STATE OF UTAH DEPARTMENT OF NATURAL RESOURCES DIVISION OF OIL, GAS AND MINING						FORM 3 AMENDED REPORT <input checked="" type="checkbox"/>				
APPLICATION FOR PERMIT TO DRILL						1. WELL NAME and NUMBER Hancock 14-14-4-1W

NEWFIELD PRODUCTION COMPANY
HANCOCK 14-14-4-1W
SE/SW SECTION 14, T4S R1W
UINTAH COUNTY, UTAH

ON-SITE PREDRILL EVALUATION

Application for Permit to Drill

Casing Schematic

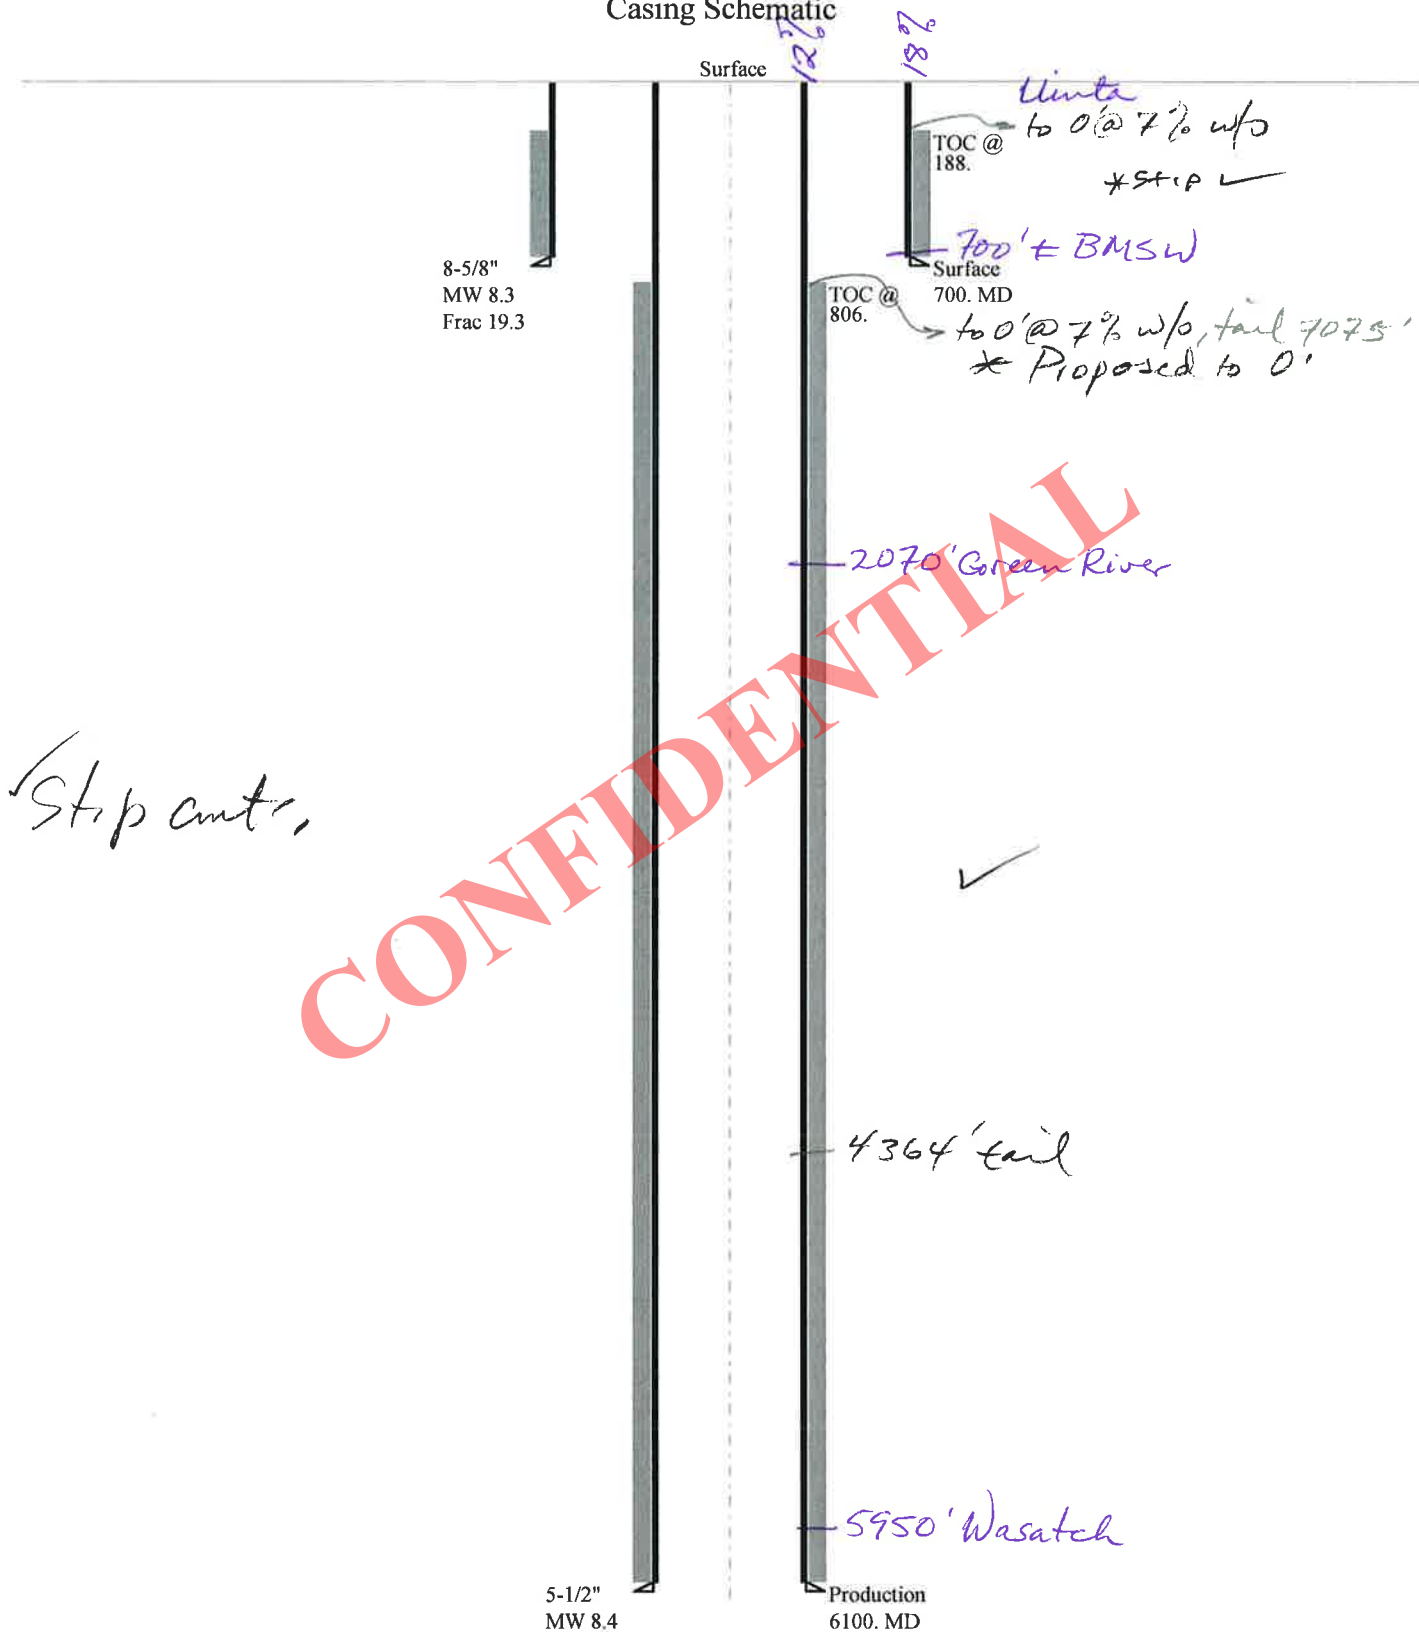
✓ Stip cont.

Collapse is based on a vertical depth of 700 ft, a mud weight of 8.3 ppg. The casing is considered to be evacuated for collapse purposes. Collapse strength is based on the Westcott, Dunlop & Kemler method of biaxial correction for tension.

Collapse is based on a vertical depth of 6100 ft, a mud weight of 8.4 ppg. The casing is considered to be evacuated for collapse purposes. Collapse strength is based on the Westcott, Dunlop & Kemler method of biaxial correction for tension.

Newfield proposes to set 300' of surface casing at this location. The depth to the base of the moderately saline water at this location is estimated to be at a depth of 700'. A search of Division of Water Rights records shows no water wells within a 10,000 foot radius of the center of Section 14. The surface formation at this site is the Uinta Formation. The Uinta Formation is made up of interbedded shales and sandstones. The sandstones are mostly lenticular and discontinuous and should not be an interconnected, high volume source of useable ground water. Surface casing should be extended to cover the estimated base of the moderately saline groundwater.

Cement volume for the 5 1/2" production string shall be determined from actual hole diameter in order to place cement from the pipe setting depth back to surface as indicated in the submitted drilling plan.
